**EAST LYME INLAND WETLANDS AGENCY
SHOW CAUSE HEARING
Monday, JUNE 9th, 2014
MINUTES**

**Re: Services: Engineering Review
Geotechnical and Sedimentation/Erosion Control Design**
Project: Antares Solar Field
Site: Grassy Hill and Walnut Hill Roads, East Lyme, Connecticut

RE: Antares Solar Farm
Grassy Hill Road, East Lyme

**DOWNSTREAM SEDIMENT DEPOSITS
UN-NAMED TRIBUTARY
CRANBERRY MEADOW BROOK**

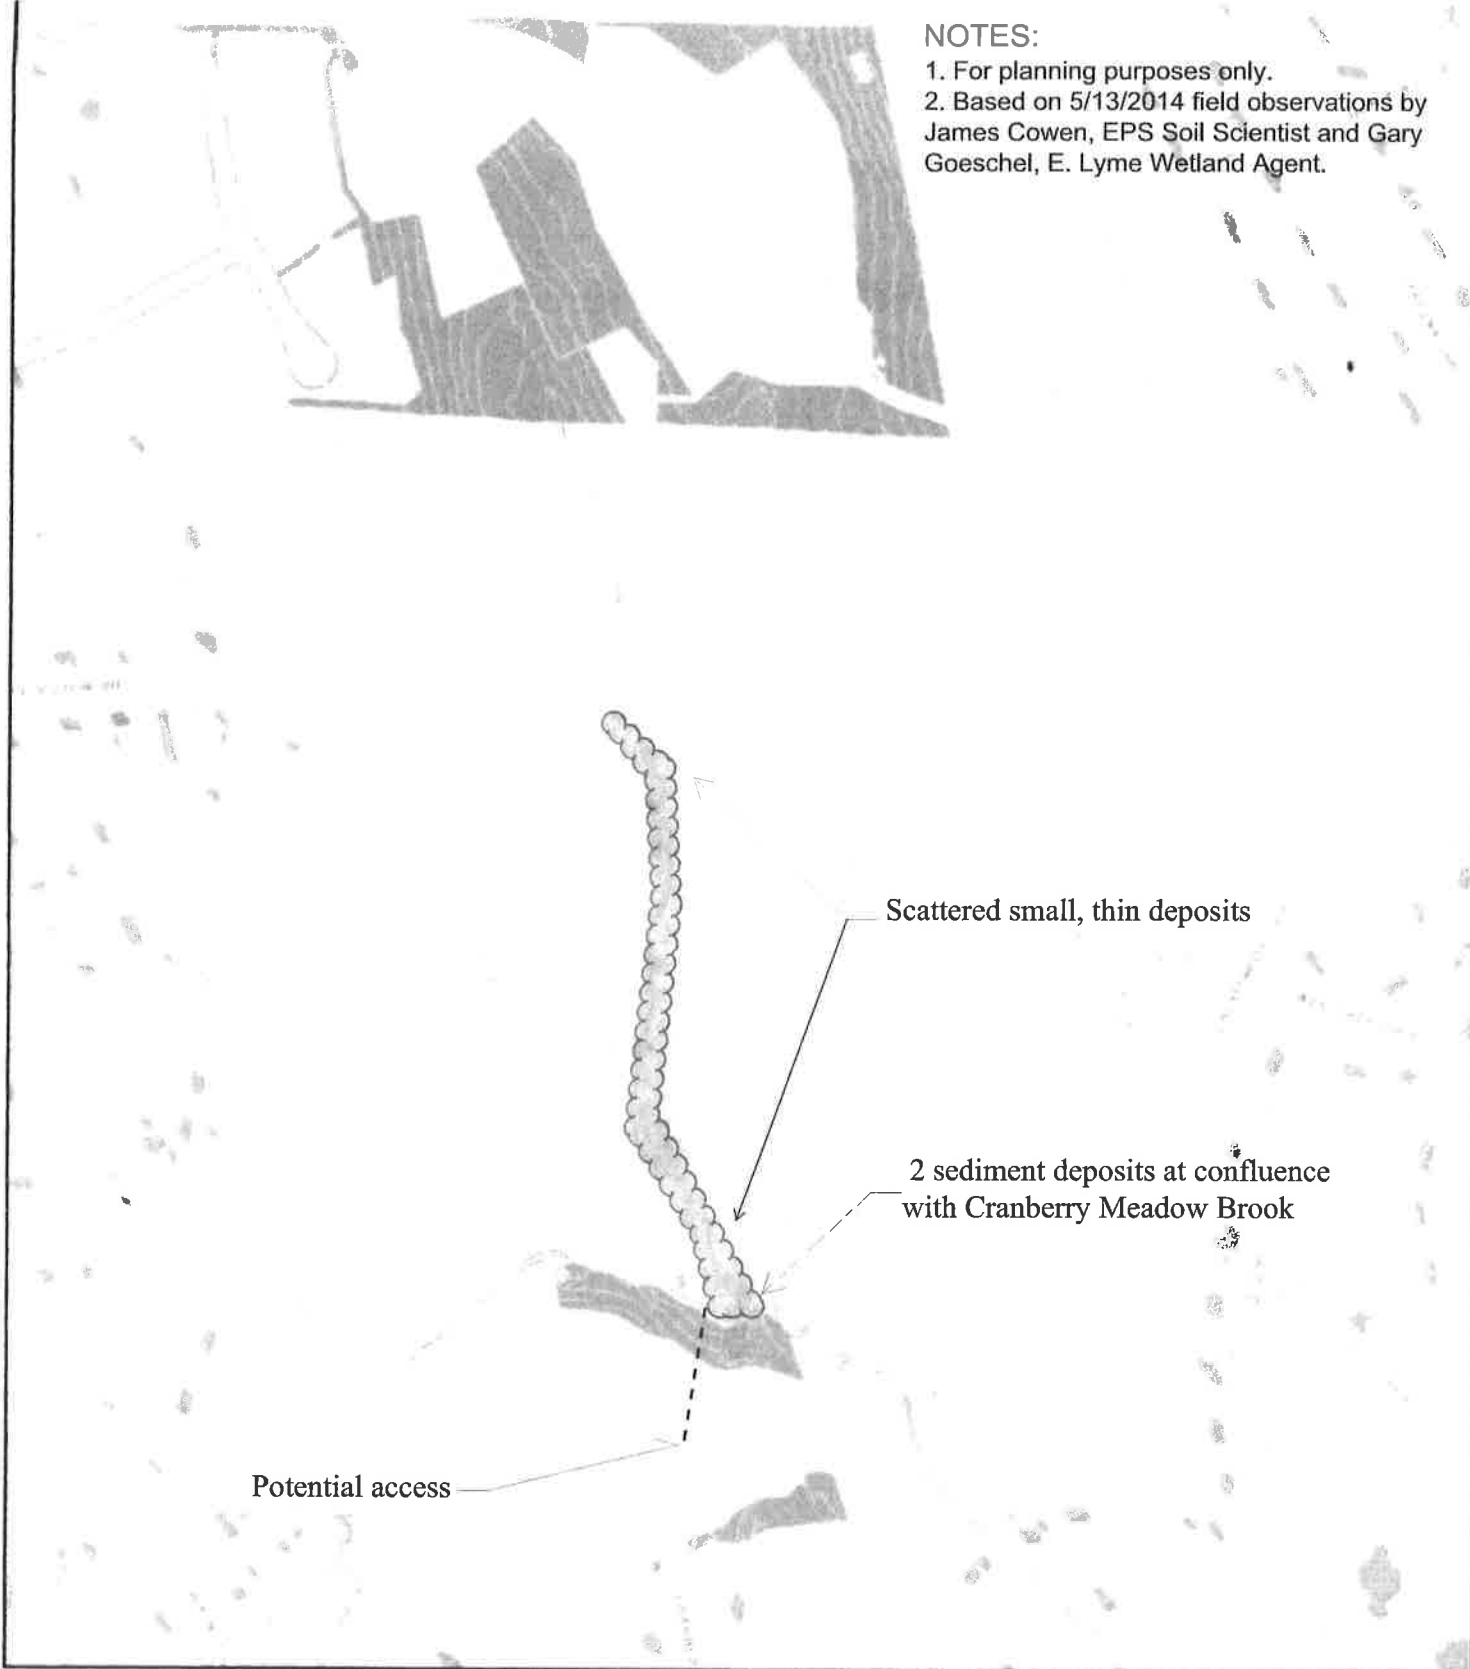
I have attached a series of photographs that are typical of the conditions we encountered, as well as a map (on East Lyme GIS base map) that shows the approximate location of the survey area and the sediment deposits. I have also reviewed the photos and mapping prepared by Mr. Goeschel, and they are consistent with my findings and observations. In my opinion, sediment remediation in the area we surveyed on May 13 is not warranted for several reasons:

- The thin, fine grained deposits in the overbank areas are very likely be stabilized by vegetation and incorporated into the soil. This would not result in an adverse impact.

- The coarser deposits in the stream average only 5” in thickness and are likely be cleansed naturally over time during high velocity storm events, without any long term adverse impact.
- The sedimentation at the confluence of the un-named tributary with Cranberry Meadow Brook has several sources other than your site.
- With the exception of the deposits at the confluence of the un-named tributary with Cranberry Meadow Brook, access would require traversing extensive areas of steep slopes, wetlands, and dense, mature forest and riparian vegetation.

We continue to believe that removal of the more extensive, thicker deposits at and immediately adjacent to your site during the upcoming dry season is appropriate. If you have any questions regarding our findings, or if you require further assistance in this matter, please feel free to contact us.
